**RE: Riverdale Public Utility District Wastewater Treatment Plant (WWTP) Project –
Tentative Waste Discharge Requirements**

Thank you for the opportunity to review the Tentative Waste Discharge Requirements for the Riverdale Public Utility District Wastewater Treatment Facility. On behalf of the Riverdale Public Utility District please find several comments regarding the Tentative Waste Discharge Requirements, described below.

WASTEWATER TREATMENT PLANT
IMPROVEMENT PROJECT
RIVERDALE PUBLIC UTILITY DISTRICT
RIVERDALE, CA
SITE PLAN
OVERALL SITE IMPROVEMENTS

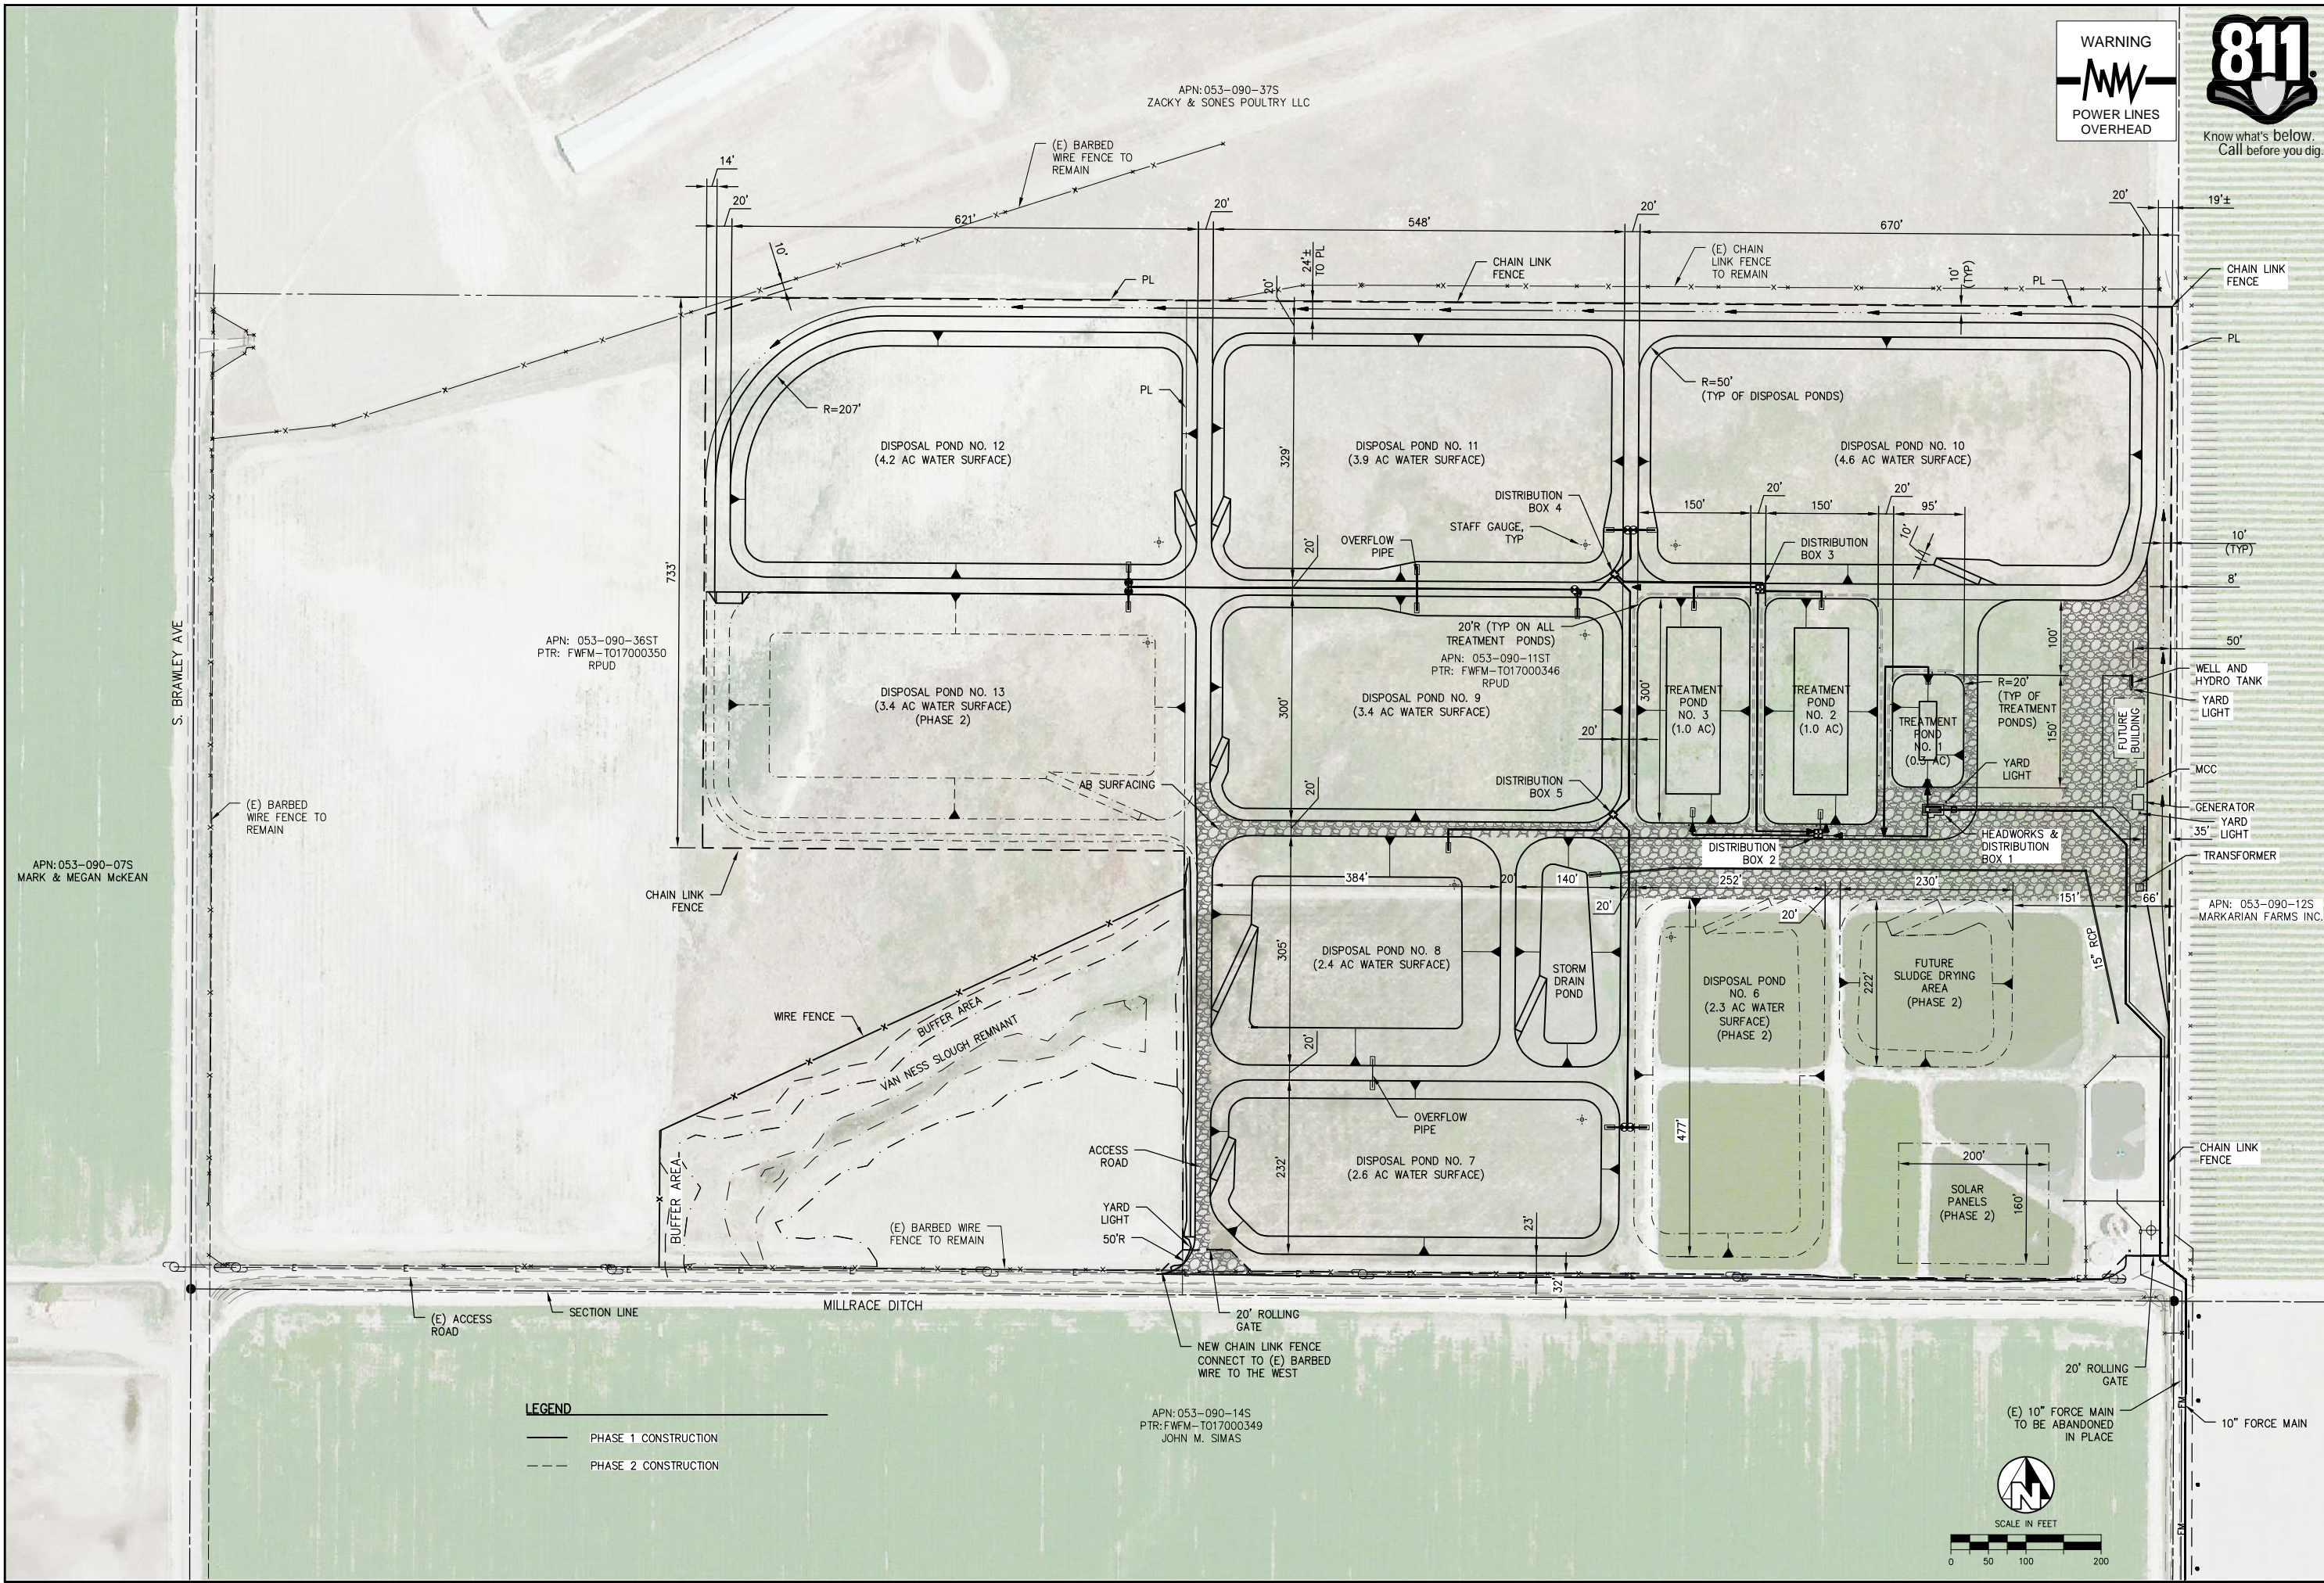
8. Attachment B – Site Plan: The disposal pond configuration has changed, with the addition of one more disposal pond. Disposal ponds 6 through 12 are proposed for Phase 1 (0.275 MGD), and Disposal pond 13 would be installed in Phase 2 to get to 0.325 MGD disposal capacity. A revised site layout is attached.
